ERRATA

Illinois Route 47 (Reed Road to U.S. Route 14) McHenry County, Illinois

Job No. P-91-101-07

August 10, 2016

LEGEND:

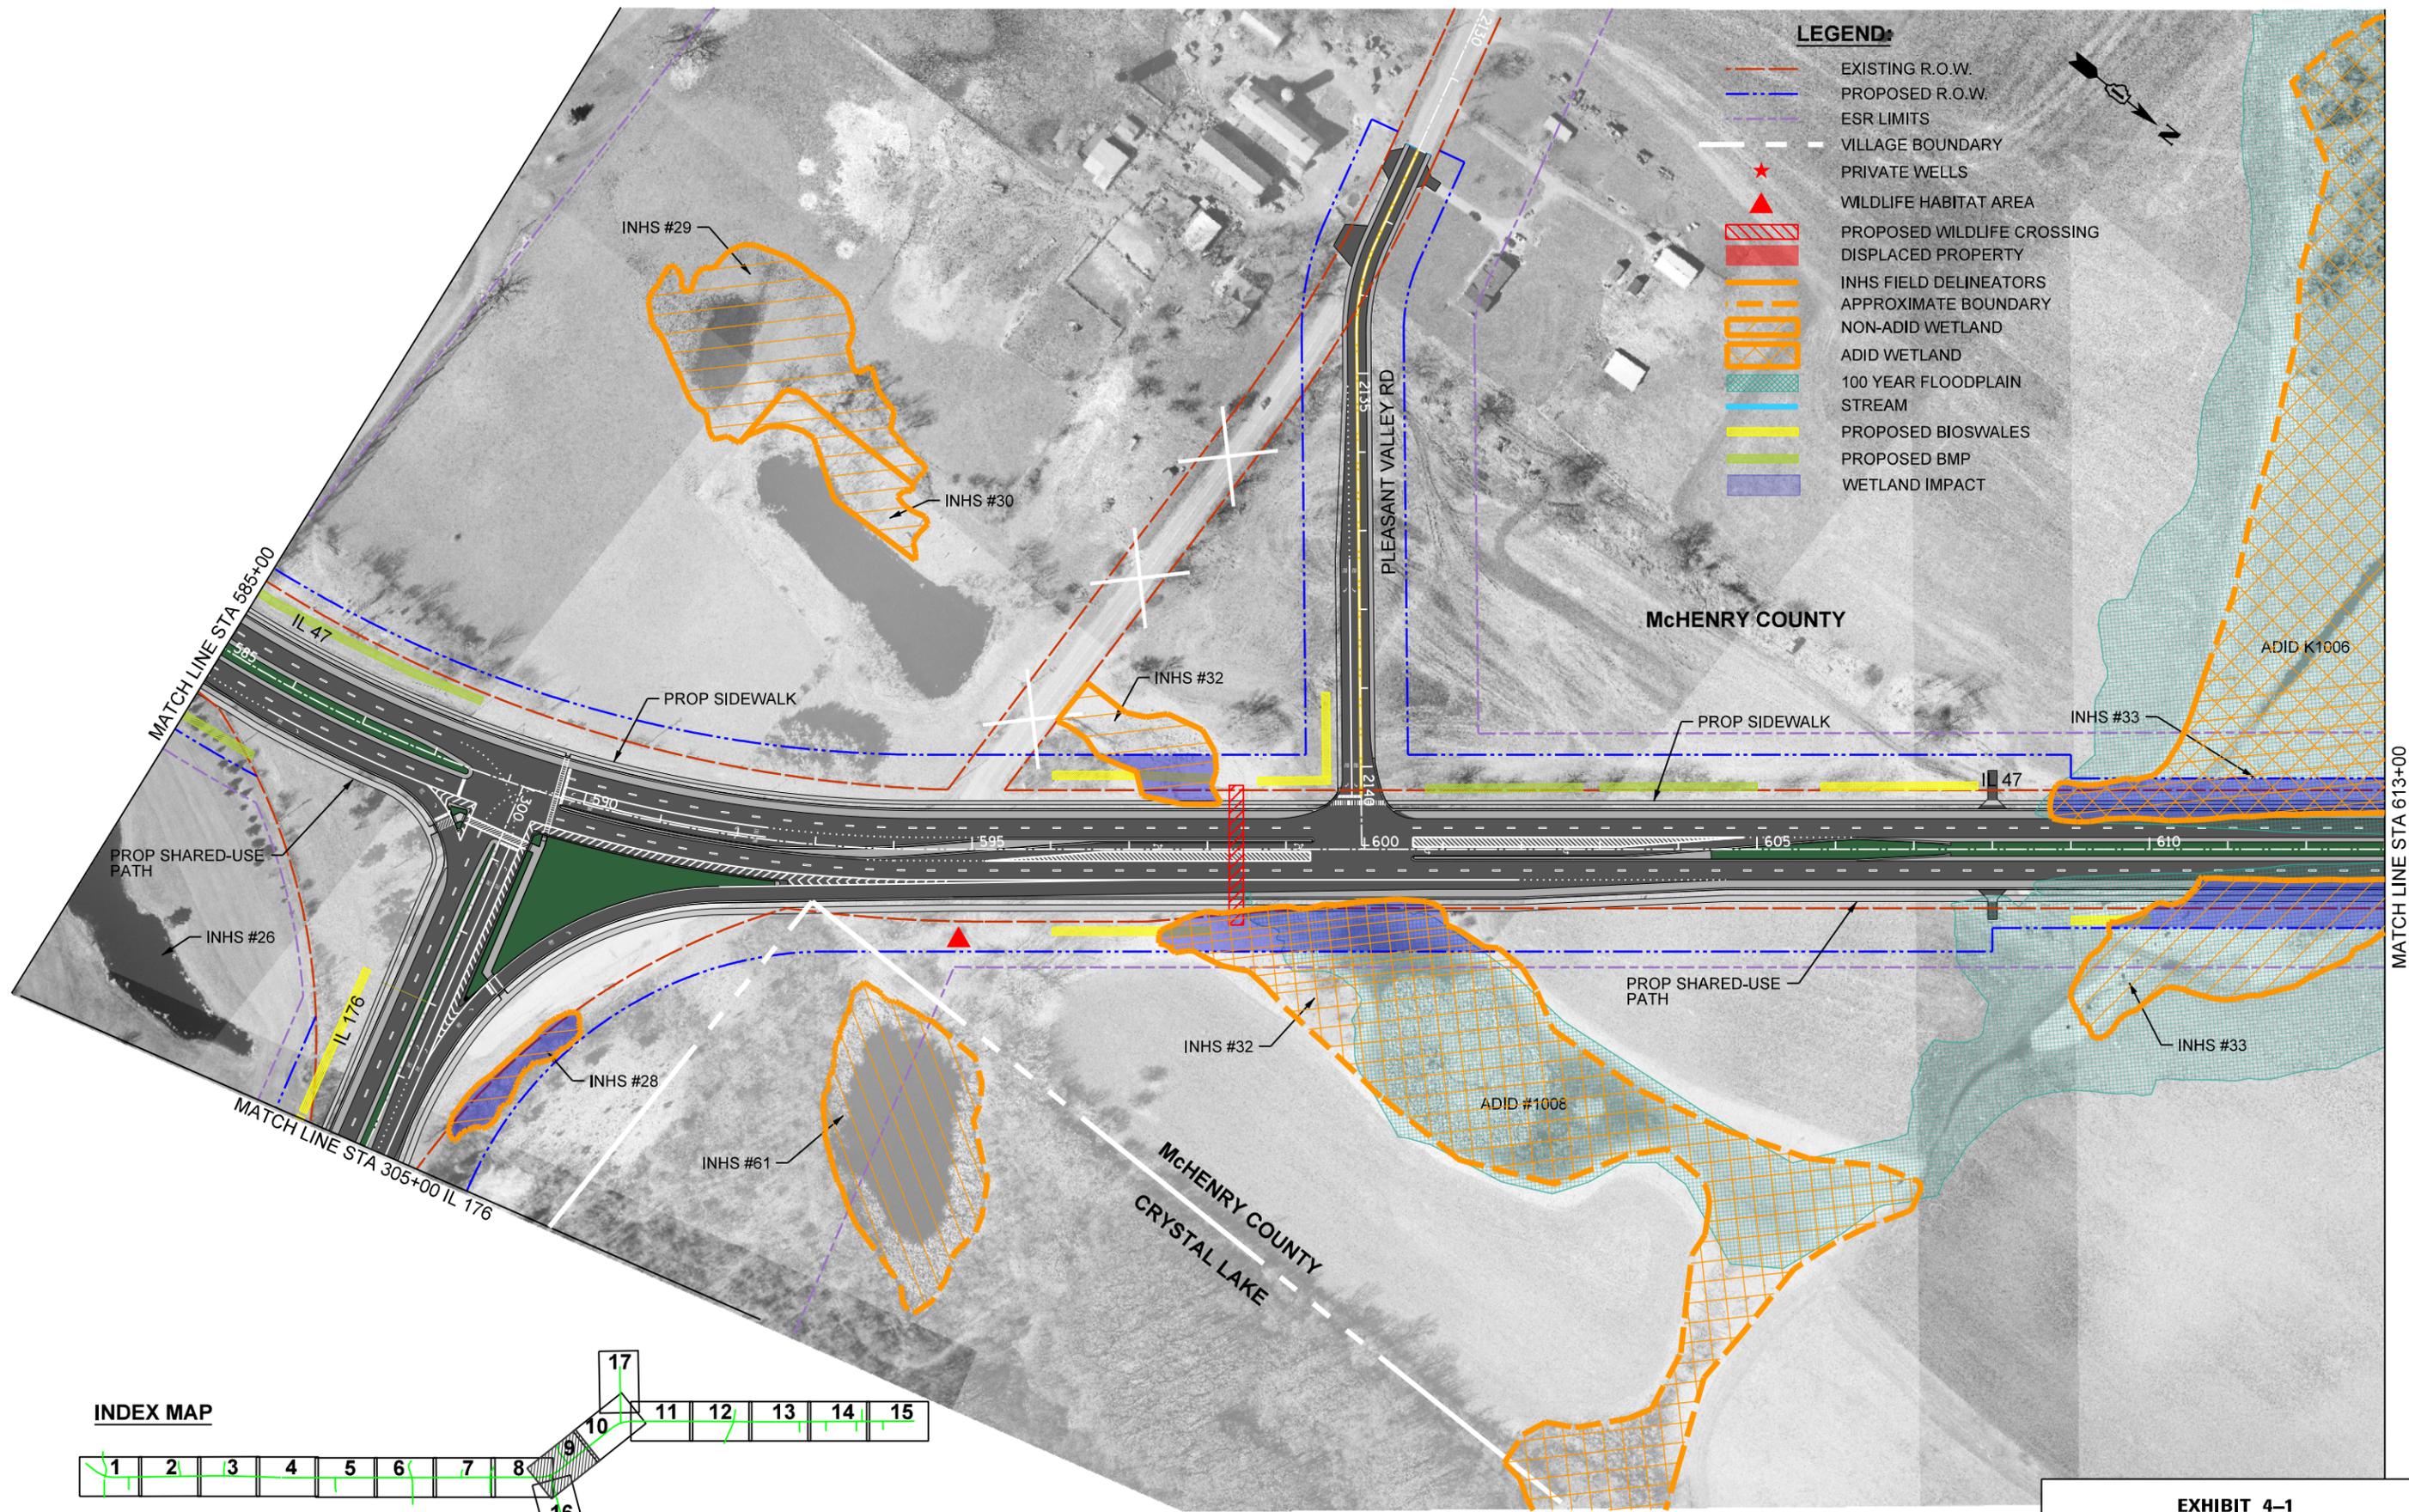
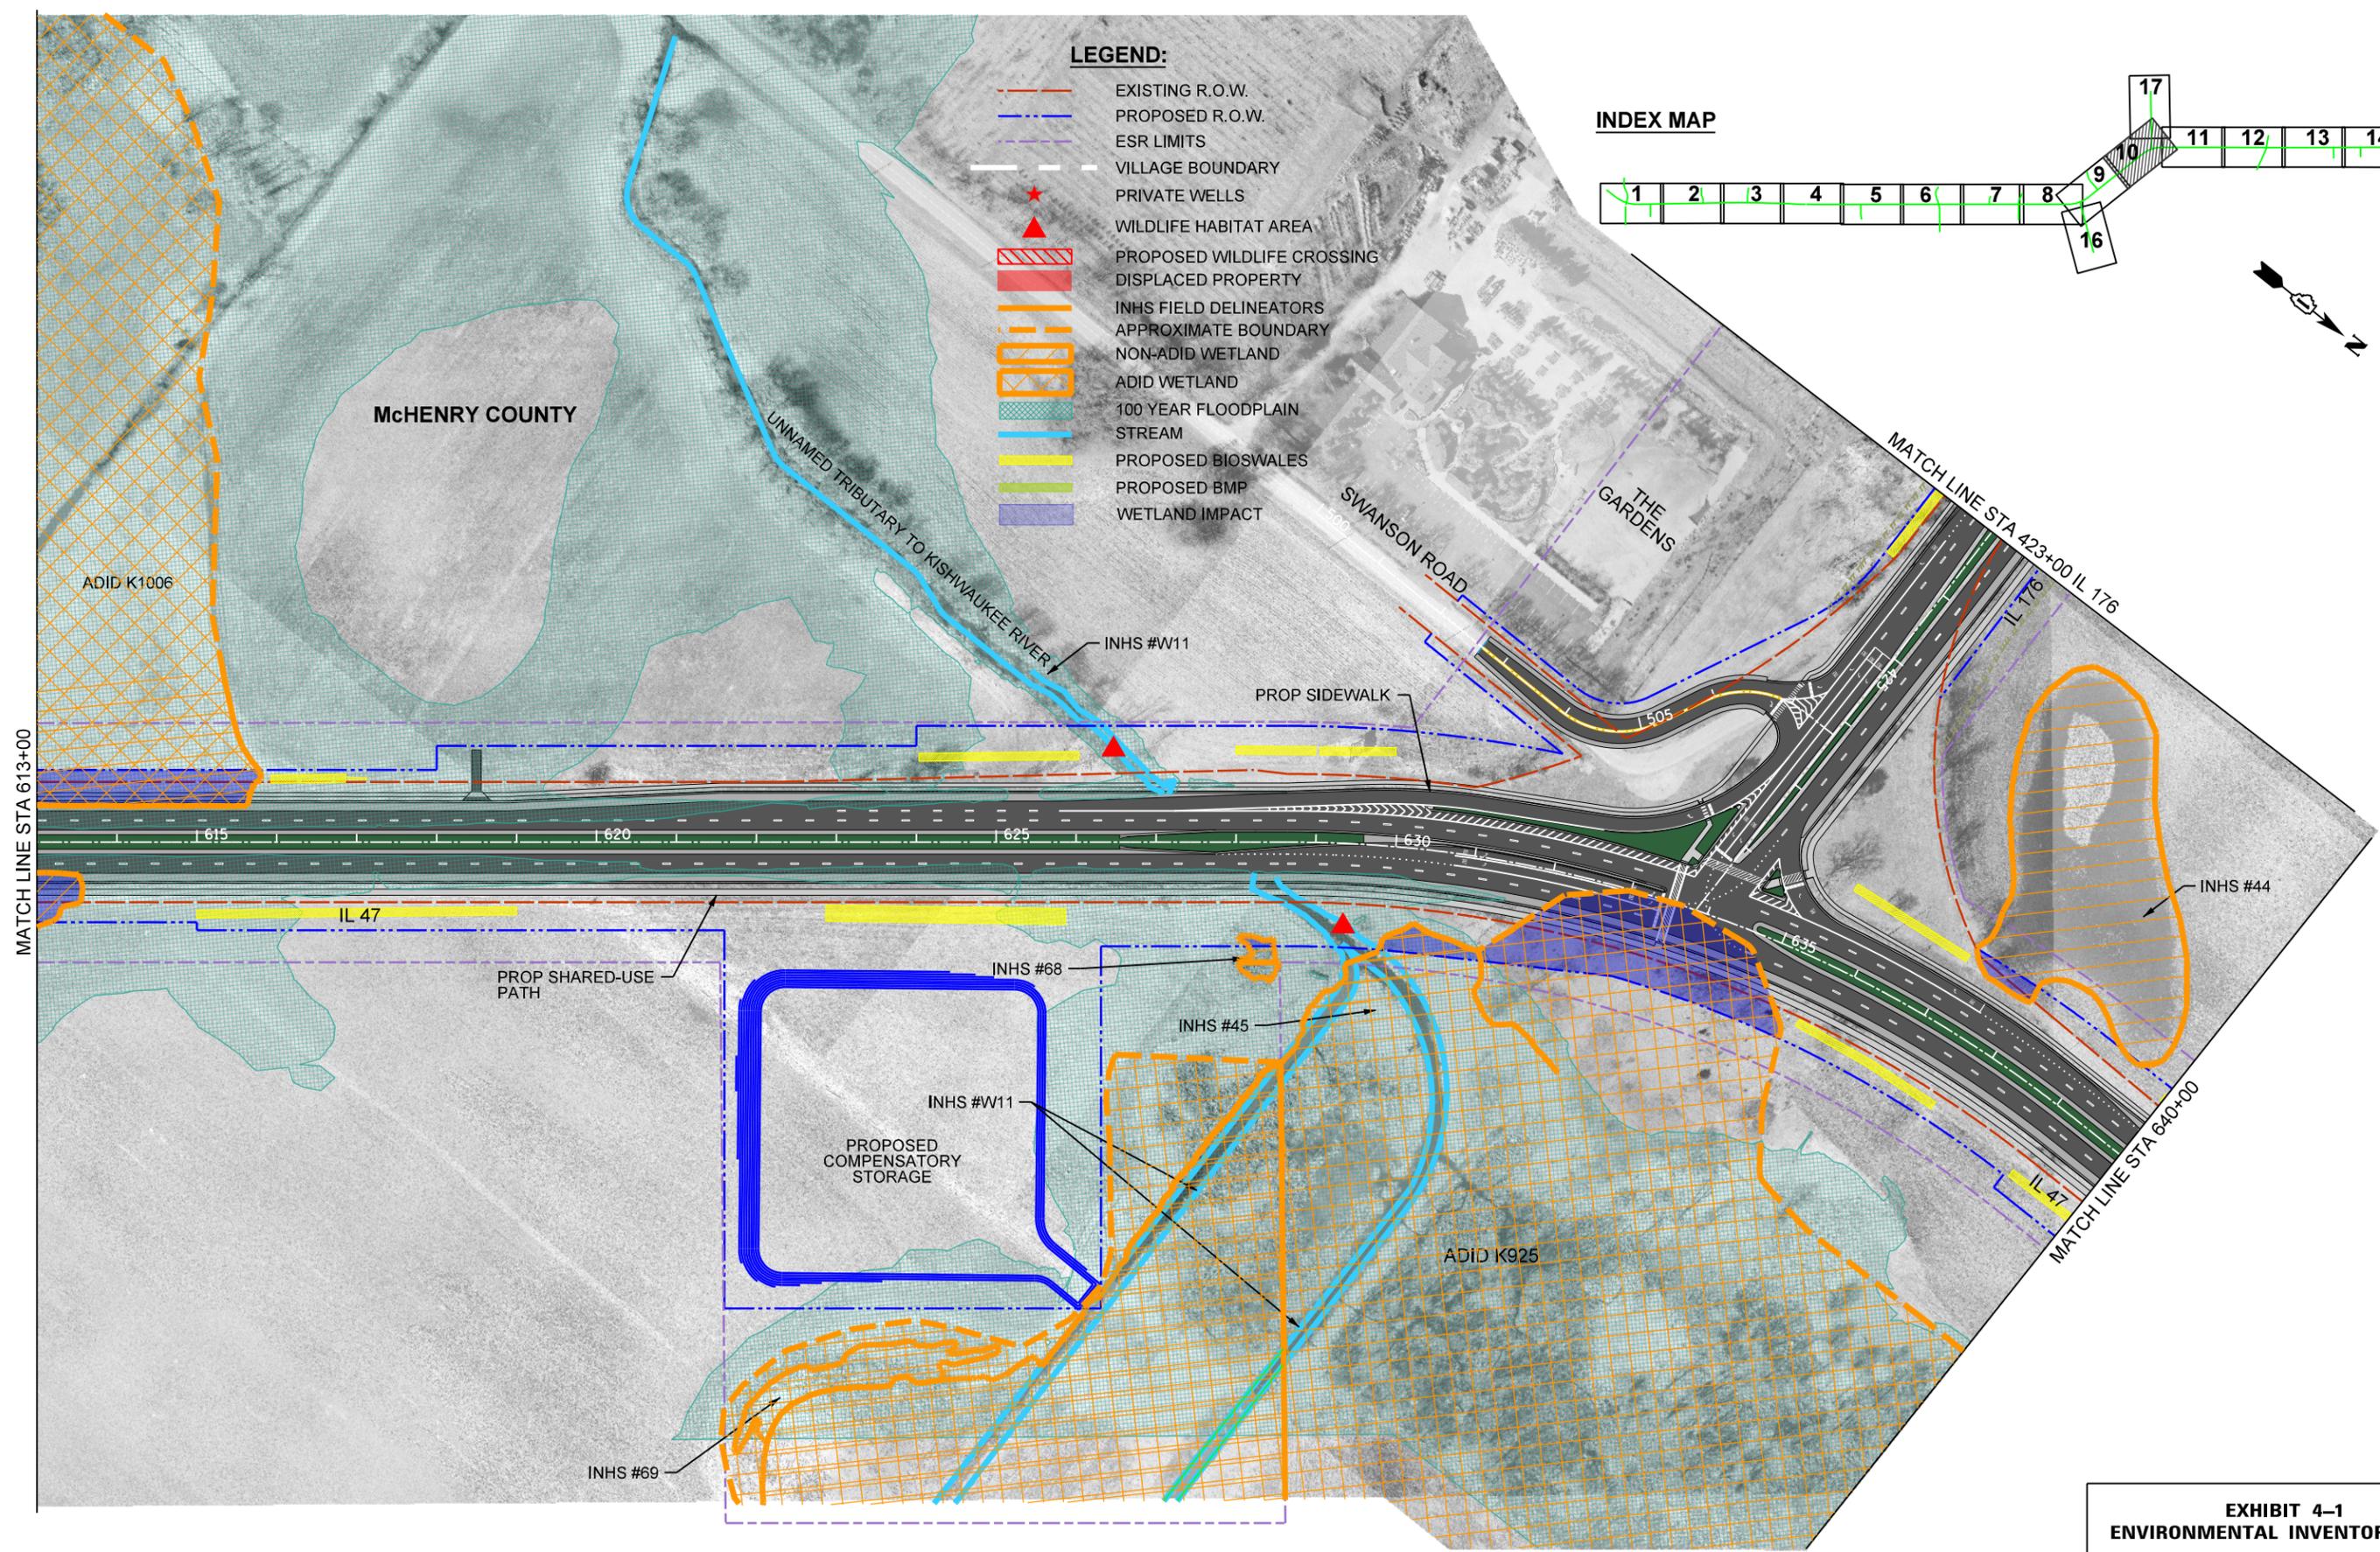
Replace Exhibit 4-1 Environmental Constraints Map to show updates to waterway names to be consistent with the Environmental Assessment, revised symbolization of the bioswales and inclusion of additional BMPs.

R	<p>A revised exhibit with a non-conflicting color scheme has been included in the Errata.</p>
87	U.S. Army Corps of Engineers	C	<p>The bioswale locations in Exhibit 4-1 should not be located within delineated wetlands or streams. Exhibit 4-1 should be revised accordingly for the final EA;</p>
		R	<p>The exhibit has been revised showing potential new locations as necessary. However, since the wetland impacts were considered to be everything within the ROW, those areas are proposed ditch locations where BMPs or bioswales are proposed; there may no longer be a functioning wetland due to construction disturbance. The design engineers will consider where regrading for the roadway and ditch work will take place while minimizing any impacts. However, there will be situations where the wetland will be graded out as part of the roadway and/or ditch construction, but these locations may be replaced with a bioswale.</p>
